ADDENDUM

No. 05 Date: 9/26/2024
Project No. 0020711.01 Attention: Leonard D'Souza
Project Name: Princess Margaret Cancer Centre
Stem Cell Transplant 2, MHC, MHDU, DSC
Address: University Health Network
610 University Avenue
Toronto ON

Addendum #: M-4

Addendum #: E-4
Revision #: 0

E0101

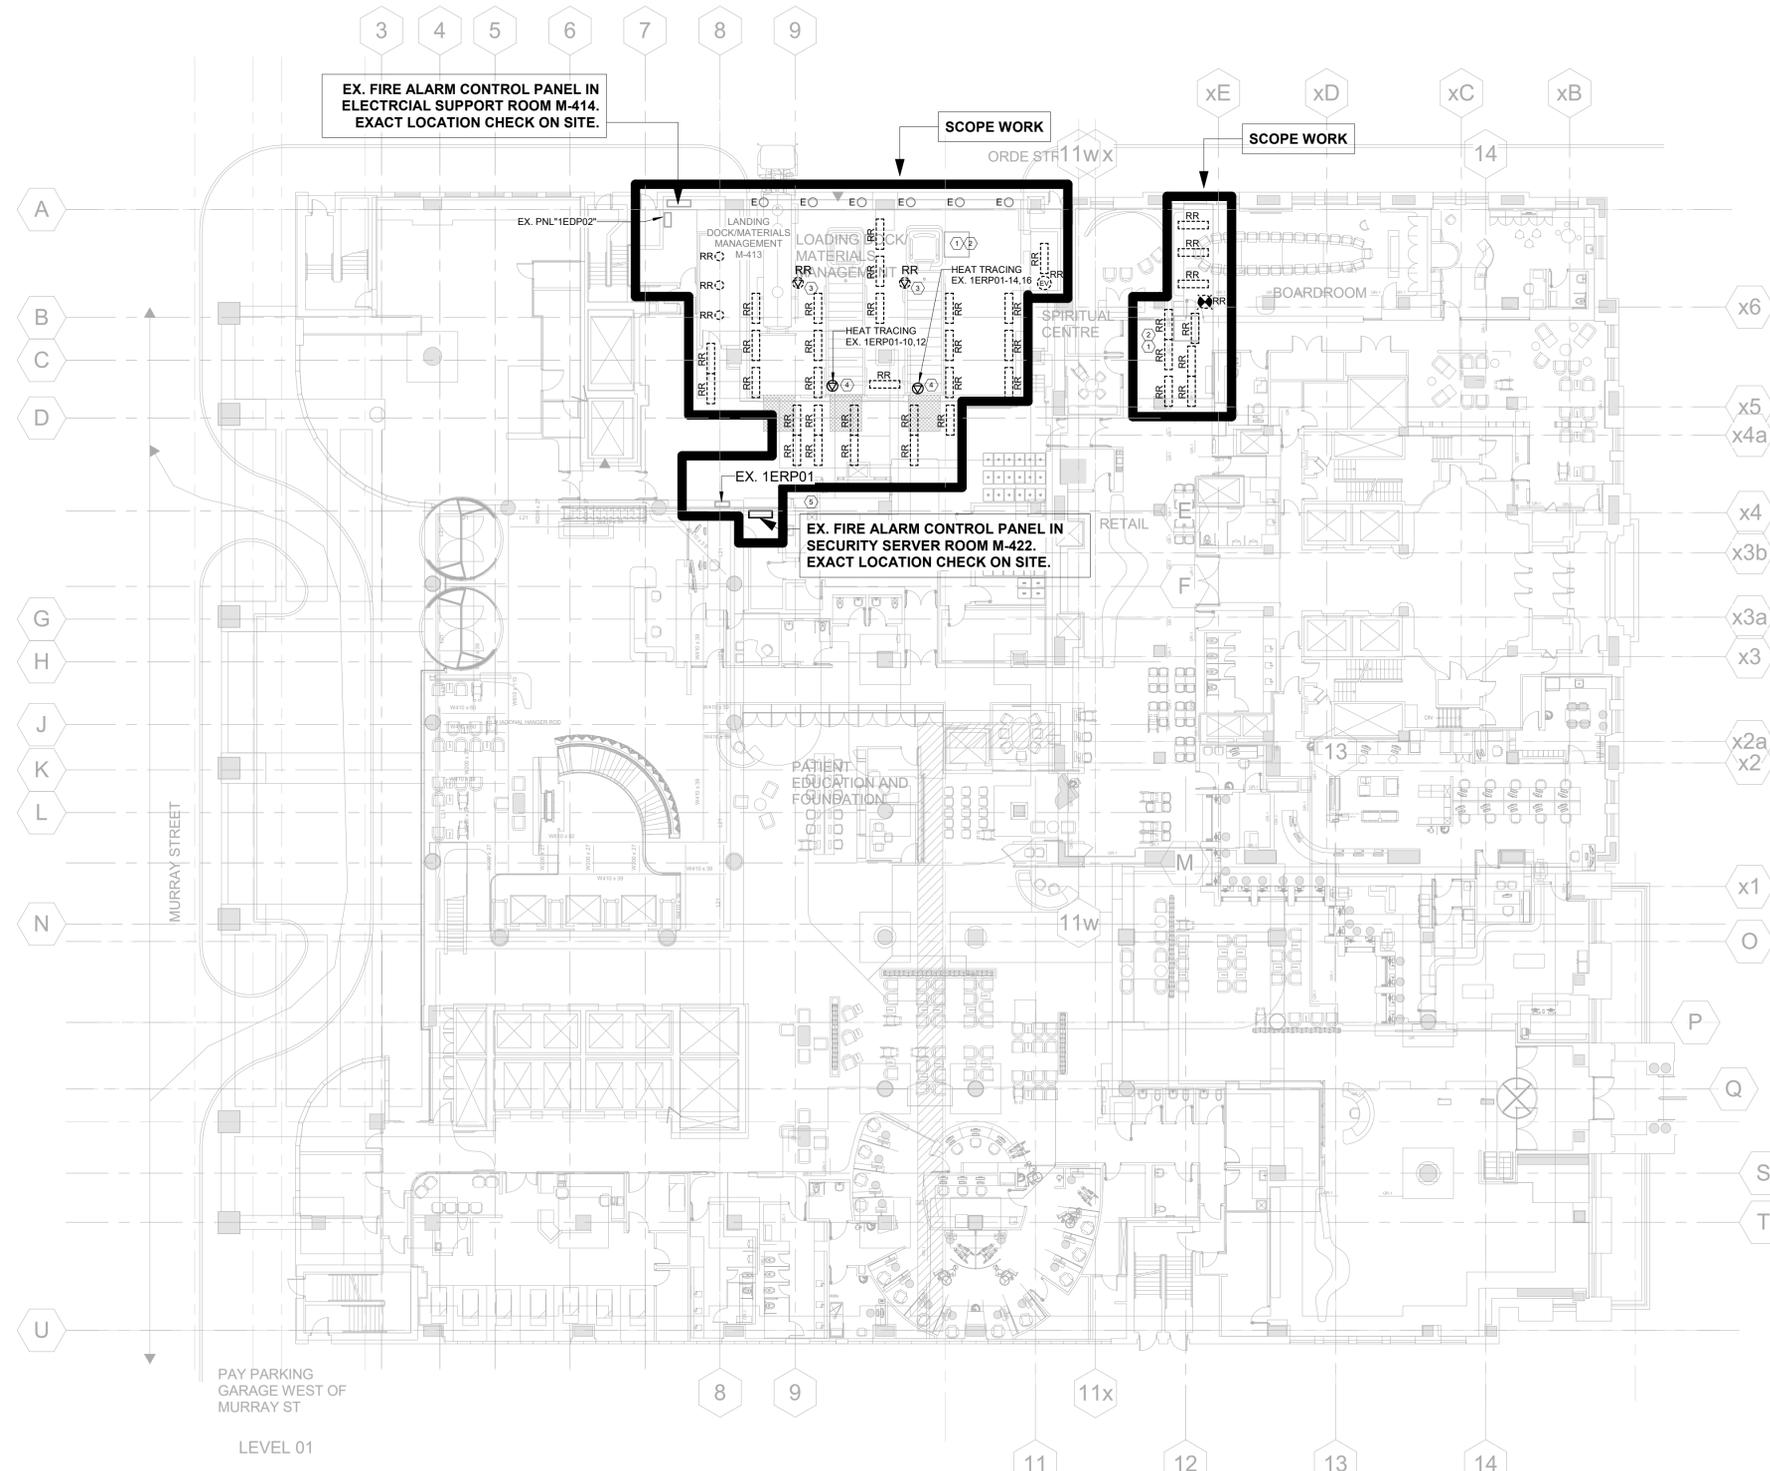
1. **Drawing E-0101 – ELECTRICAL - 1ST FLOOR DEMOLITION & NEW WORK PLAN (MH)**
 - Modification to notes as clouded, to provide provisions to disconnect, reconnect and test shaft lighting affected by demolition.
2. **Drawing E-0104 – ELECTRICAL - 4TH FLOOR DEMOLITION & NEW WORK PLAN (MHDU)**

4	LIGHTING, POWER CONDUITS AND CONNECTIONS IN SHAFTS TO BE DISCONNECT TO NEAREST JUNCTION BOXES. REINSTALL AND TEST AFTER NEW WORK IS COMPLETE. COORDINATE WITH MECHANICAL ON SITE FOR DETAILS.

E0104

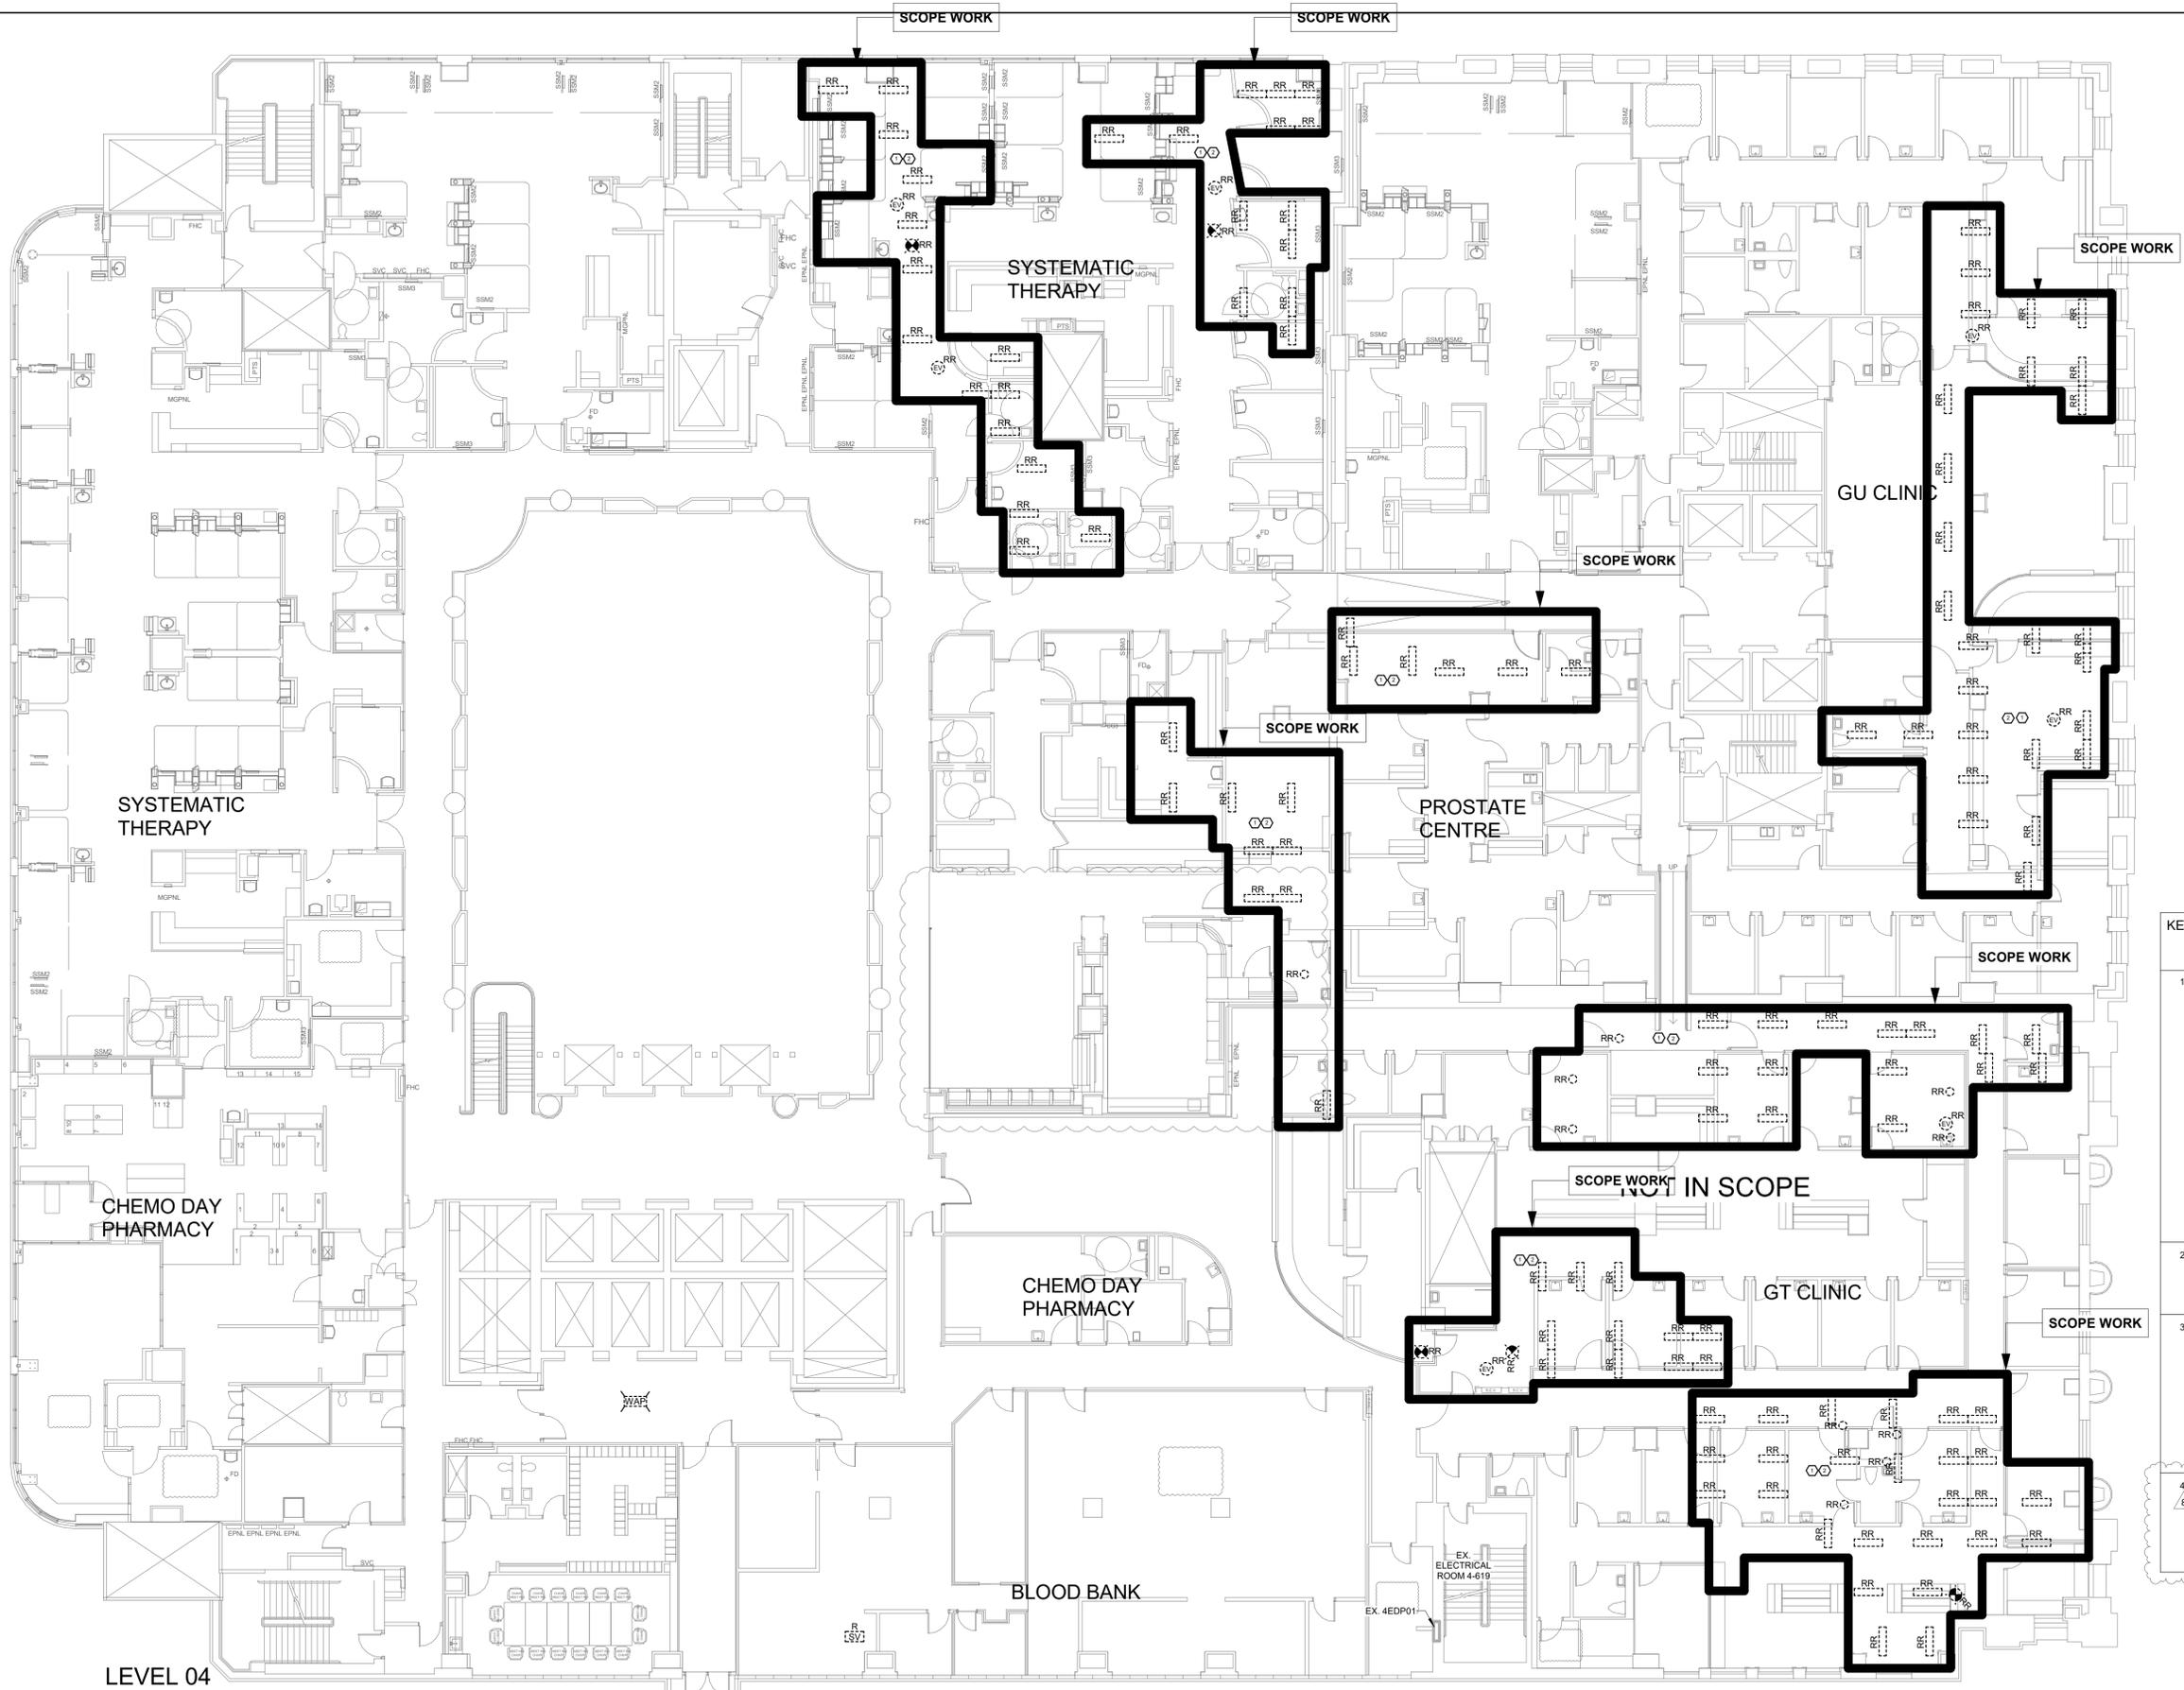
- Modification to notes as clouded, to provide provisions to disconnect, reconnect and test shaft lighting affected by demolition.

- 4 LIGHTING, POWER CONDUITS AND CONNECTIONS IN SHAFTS TO BE DISCONNECT TO NEAREST JUNCTION BOXES. REINSTALL AND TEST AFTER NEW WORK IS COMPLETE. COORDIANTE WITH MECHANICAL ON SITE FOR DETAILS.

E0106

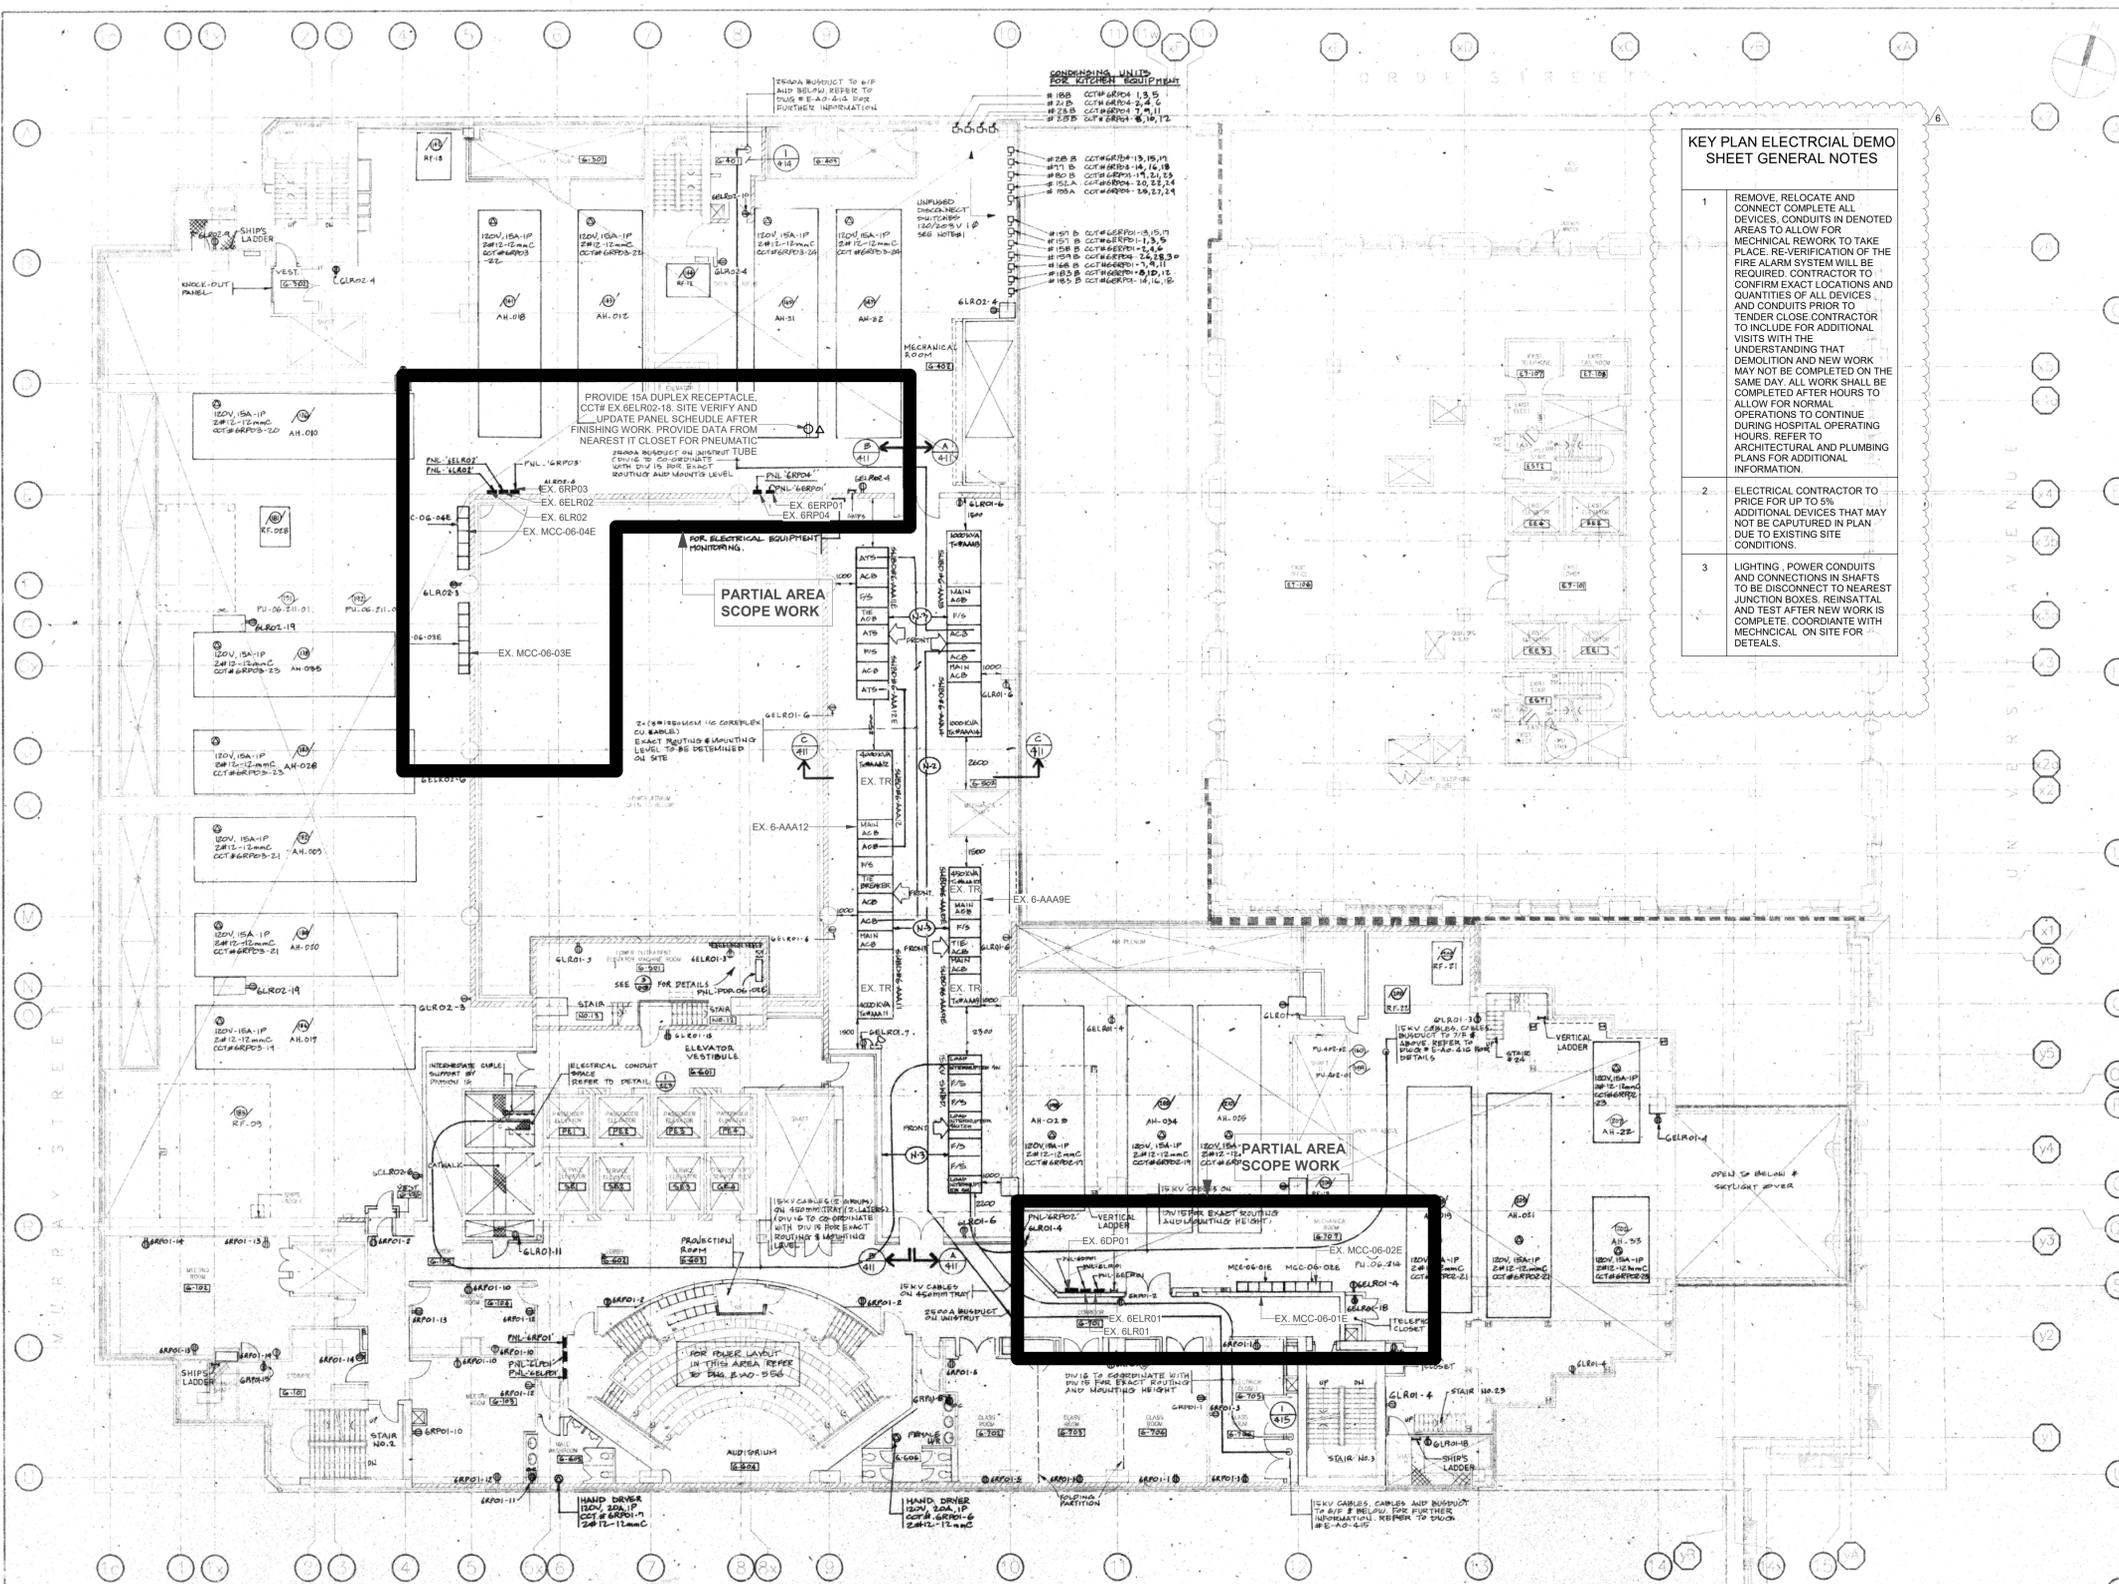
- Modification to notes as clouded, to provide provisions to disconnect, reconnect and test shaft lighting affected by demolition.

- 2 ELECTRICAL CONTRACTOR TO PRICE FOR UP TO 5% ADDITIONAL DEVICES THAT MAY NOT BE CAPTURED IN PLAN DUE TO EXISTING SITE CONDITIONS.
- 3 LIGHTING, POWER CONDUITS AND CONNECTIONS IN SHAFTS TO BE DISCONNECTED TO NEAREST JUNCTION BOXES. REINSTALL AND TEST AFTER NEW WORK IS COMPLETE. COORDINATE WITH MECHANICAL ON SITE FOR DETAILS.
